GROUP	MODEL
Safety Recall Campaign	2017-2018MY Forte (YDm)
NUMBER	DATE
SC210	August 2021

SAFETY RECALL CAMPAIGN

OIL PAN & OIL FILTER REPLACEMENT FOR 2.0L NU MPI ENGINE (SC210)

New Oil Pan Assembly with Magnets

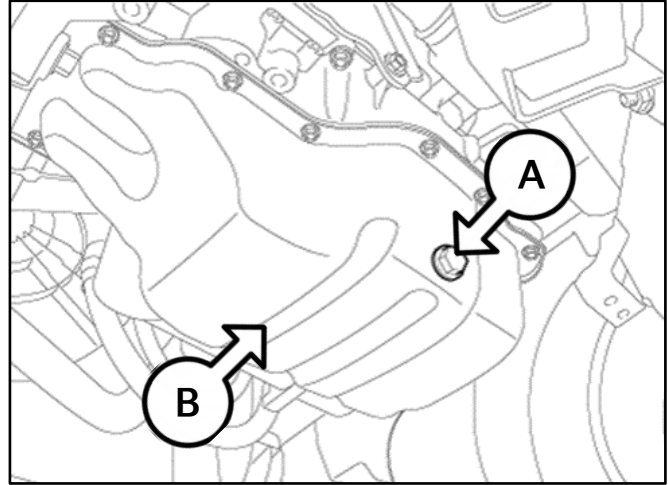
This bulletin provides the procedure to replace the engine oil pan on some 2017-2018MY Forte (YDm) vehicles produced from June 5, 2017 through July 24, 2017 with a new one that includes magnets. In addition, the oil filter in these vehicles is also to be replaced. The subject vehicles may exhibit abnormal engine noise, an oil pressure warning lamp and/or MIL on due to the conditions described below. The engine oil pump contains a variable relief plunger that controls oil pressure. Over time, normally occurring foreign particles that are not captured by the oil filter can become stuck in the plunger due to a sharp edge on the plunger, resulting in reduced oil pressure and engine lubrication. If the vehicle is continually operated with this condition, the engine can be damaged and loss of motive power may occur, increasing the risk of a crash. Follow the procedure outlined in this publication to install the new engine oil pan and replace the oil filter with the parts listed in this bulletin. The new engine oil pan includes two (2) magnets to capture any foreign particles in the oil pan to prevent them from becoming stuck on the oil pump plunger. Before conducting the procedure, verify that the vehicle is included in the list of affected VINs.
